**NAMAS WIND FARM GRID CONNECTION (KLEINSEE, NORTHERN CAPE):
APPLICATION FOR AMENDMENT OF THE ENVIRONMENTAL AUTHORISATION
AVIAN SPECIALIST COMMENT – 2021**

The original layout proposed and amended by Genesis Namas Wind (Pty) Ltd, was part of the impact assessment undertaken in 2017-2018 and that was approved and given environmental Authorisation in 2019. This proposed (2021) amendment addresses:

Figure 1: The change in the proposed 132 kV grid connections: (i) corridor width (300m to 600 m) to the Gromis substation (top), and (ii) the increased size of the corridor into the Gromis substation.

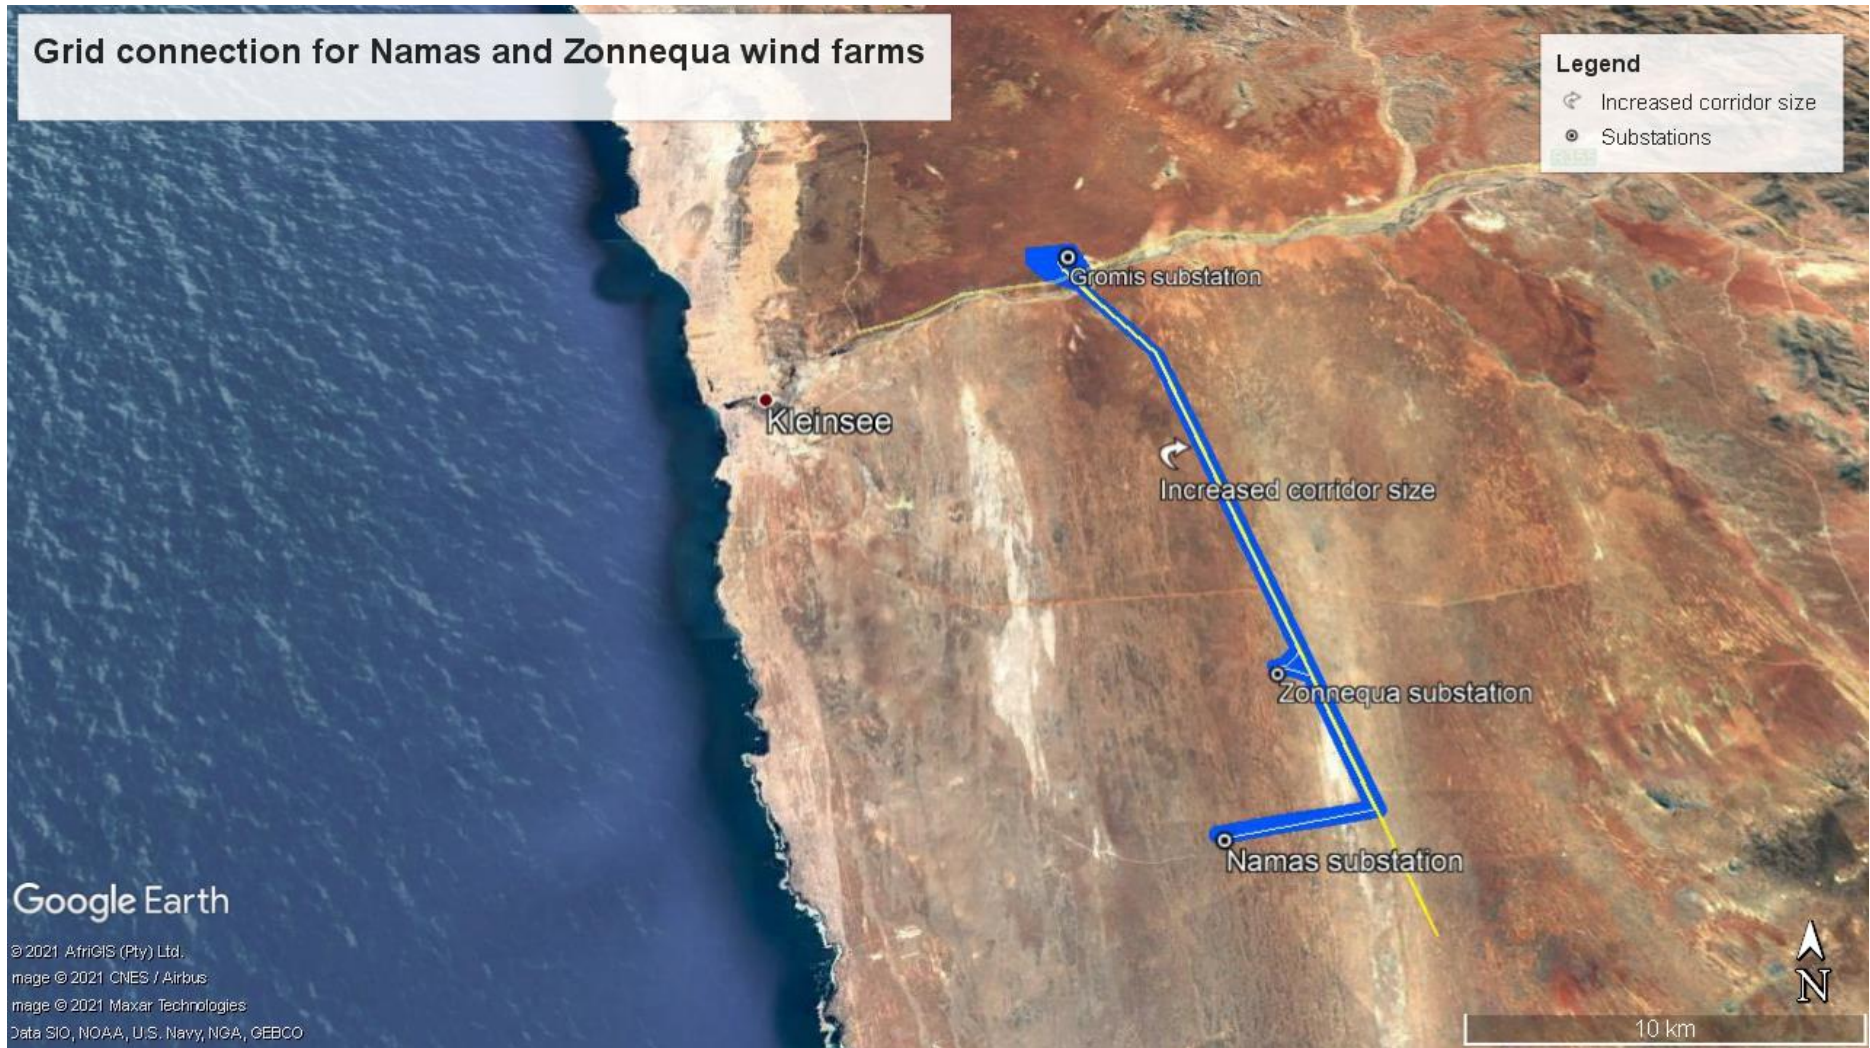
The new amendment proposes that the width of the approved corridor increases from 300m to 600m in width for the length of line from the Gromis substation to the Zonnequa on-site substation (blue in Figure 1). Given that the power line exporting the energy from the two wind farms will still lie adjacent, and the pylons staggered, to the proposed 400 kV line, the risk to birds, particularly the collision-prone bustards will not change. This is because the alignment next to the proposed 400 kV line will remain (whatever side it is placed – east or west) and that provides increased visibility of the two lines from the staggered pylon effect and the addition of bird diverters to both lines will increase visibility, and decrease avian risks, further.

The habitat immediately to the north of the Gromis substation is highly altered and compromised by mining activities and, as such, holds no importance to the local avifauna. Thus, the widening of the corridor to accommodate a line from the north will not impact the impact to the avifauna in the area.

The previous mitigations outlined in Simmons and Martins’ (2018) Avian Assessment report, particularly the staggered pylon mitigation (Pallet, Simmons and Brown in prep) should be applied, as the possibility of reducing the impacts with bird diverters is minimal for the Red Data bustards at the proposed Namas to Zonnequa grid connection.
